# Access Compliance Report

## Public Rights-of-Way (Curb Ramps)

Intersection ID: 30536	Main Street: S_TRYON_ST	Cross Street: BENNINGTON_PLACE_DR	Location: NW
ADA ID: 2BB7CD0AD1A5	Ramp Type: PerpDiag	Initial Pass/Fail: Fail	Overall Compliance: No
Severity Score: 21.25			
Codes/Mitigation Info/Possible Solution		Field Measurements/Component Compliance

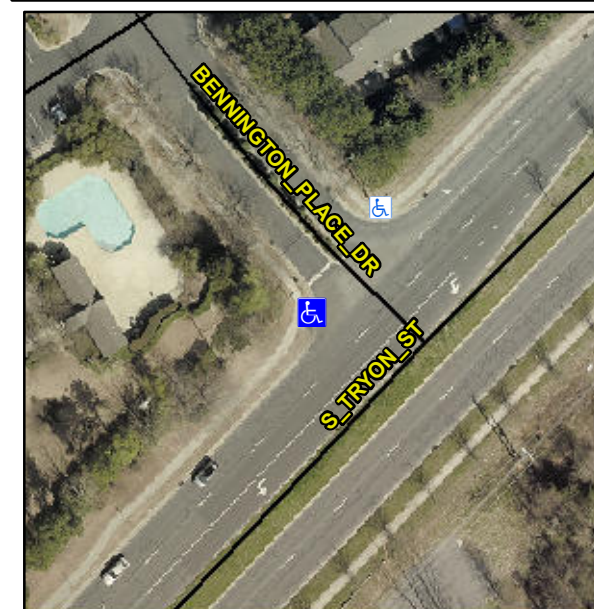
**Not Found, R304.5.1, R304.2.2**

Compliance	Description	Data	Compliance	Description	Data
N/A	Ramp Length (in)	80.0	No	Ramp Slope (%)	10.5
No	Ramp Width (in)	47.0	Yes	Ramp XSlope (%)	0.7
N/A	Flare Type LT	N/A	N/A	Flare Type RT	N/A
N/A	Flare Slope LT (%)	N/A	N/A	Flare Slope RT (%)	N/A
N/A	Flare Traversable LT?	N/A	N/A	Flare Traversable RT?	N/A
N/A	Landing Length (in)	N/A	N/A	DWS Provided?	N/A
N/A	Landing Width (in)	N/A	N/A	DWS Contrast?	N/A
N/A	Landing Slope (%)	N/A	N/A	DWS Length (in)	N/A
N/A	Landing X Slope (%)	N/A	N/A	DWS Full Width?	N/A
N/A	Landing Curb? (Y/N)	N/A	N/A	DWS Offset (in)	N/A
N/A	Shared Landing?	N/A			
N/A	Gutter Ponding?	N/A	N/A	Gutter Slope (%)	N/A
N/A	Gutter Lip Ht (in)	1.5	N/A	Gutter X Slope (%)	N/A
N/A	Painted X Walk1?	No	N/A	Painted X Walk2?	No
	X Walk 1 Direction	To SE		X Walk 2 Direction	To NE
N/A	X Walk 1 Width (in)	N/A	N/A	X Walk 2 Width (in)	N/A
	X Walk 1 Slope (%)	1.8		X Walk 2 Slope (%)	0.9
	X Walk 1 X Slope (%)	0.8		X Walk 2 X Slope (%)	0.3

**Remove & Replace Curb Ramp With Two New Directional Ramps or Equivalent.**
